# Spartan Fire, LLC

## Technical Service Bulletin

**TSB21-160-001**

**CONDITION:** Heater Hose supply for HVAC used in conjunction with DEF.

**FIG. 2.1**

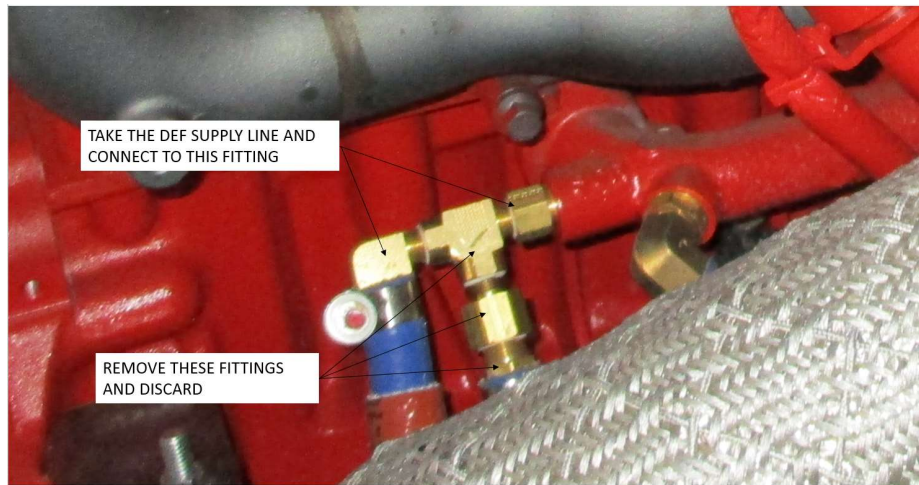
1. Carefully disconnect the supply hose and fittings as shown in picture below and reconnect DEF line. Utilize a pan to catch any fluid that may spill. Save clamps, heater hose, and fire sleeve. *Refer to Figure 2.1*

**FIG. 2.2**

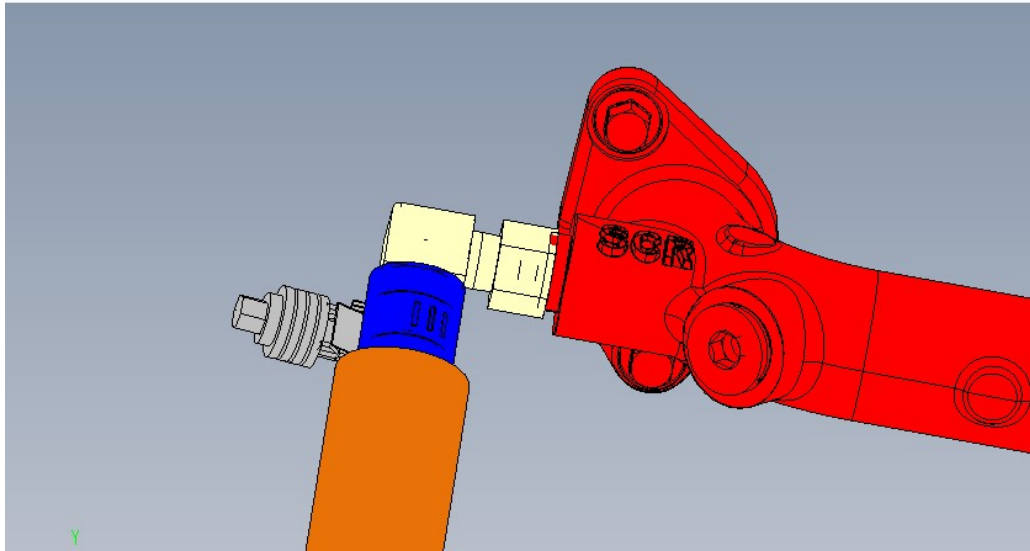
End result of the DEF line connection should look like Figure 2.2.  
Ensure to torque fittings per 0208-BB1.

**FIG 3.1**

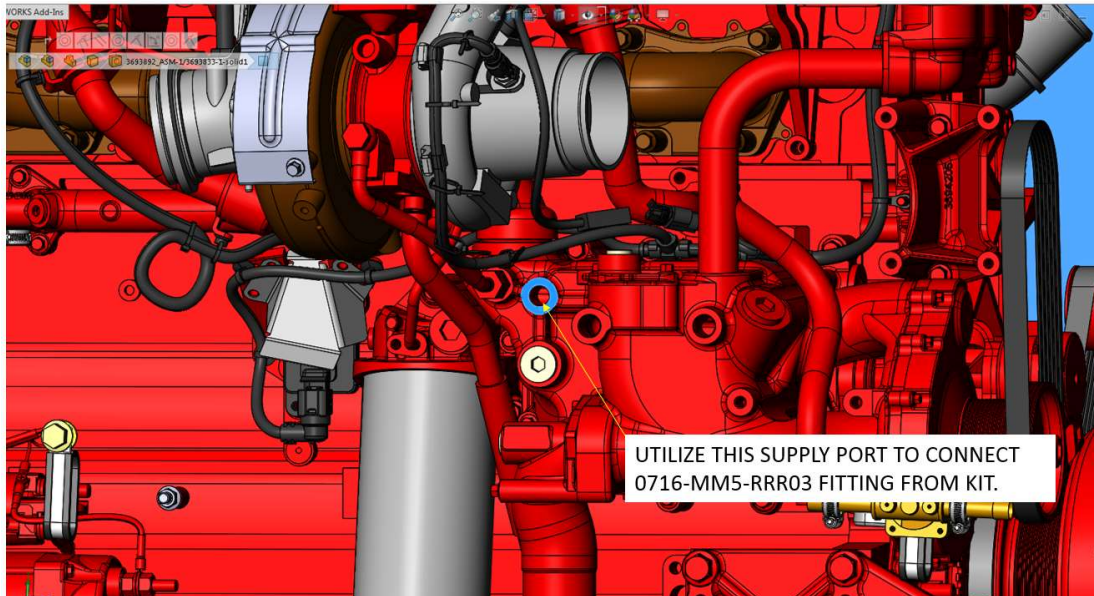
2. Locate supply port on right side of engine as shown in Figure 3.1.

FIG 3.2

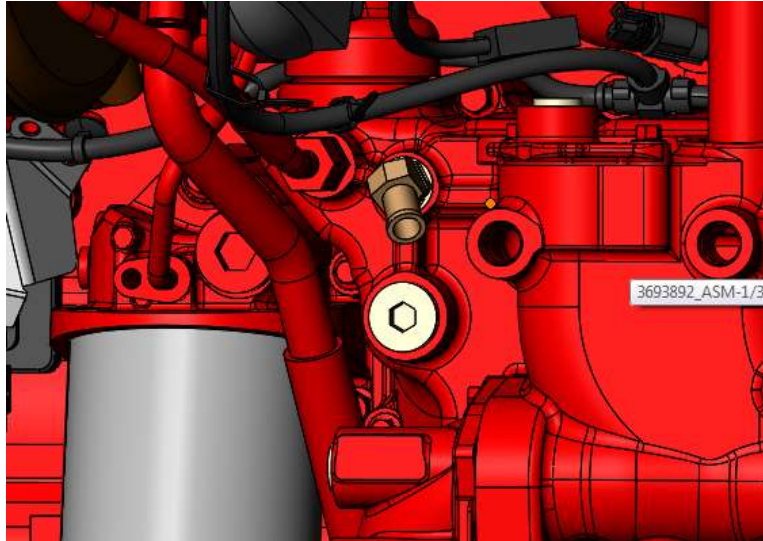
3. Install new fitting 0716-MM5-RRR03 in supply port as shown in Figure 3.2

**FIG 4.1**

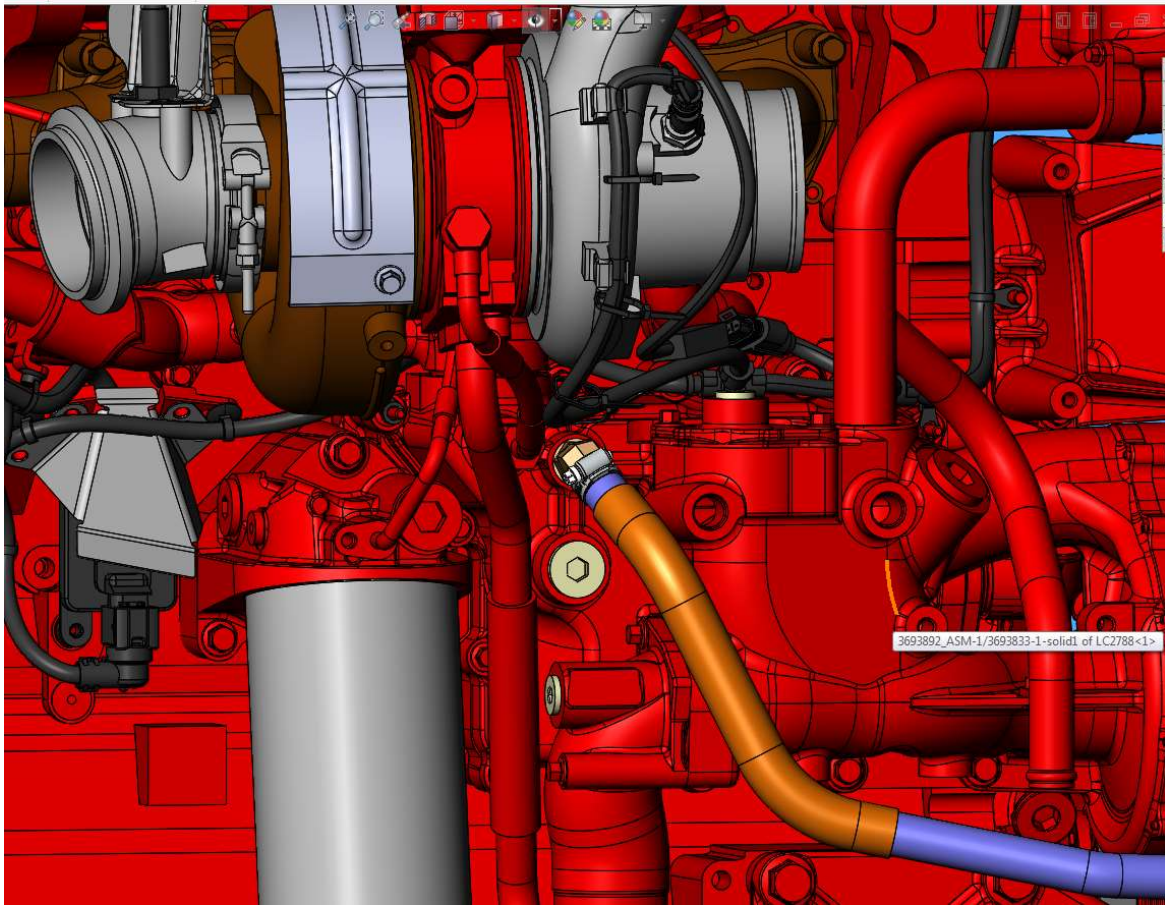
4. Utilizing remaining line from step 1, connect heater hose line to 0716-MM5-RRR03. See Figure 4.1.

**\*\*Please note:** To ensure heater hose is not too sloppy remove about 12- 18 inches of hose from open end and slide existing fire sleeve out of the way prior to cutting hose. Then secure heater hose with fire sleeve to fitting with existing 0429-BB1-001 clamp.

**Clamp must be torque to 43-45 IN/LBS.**
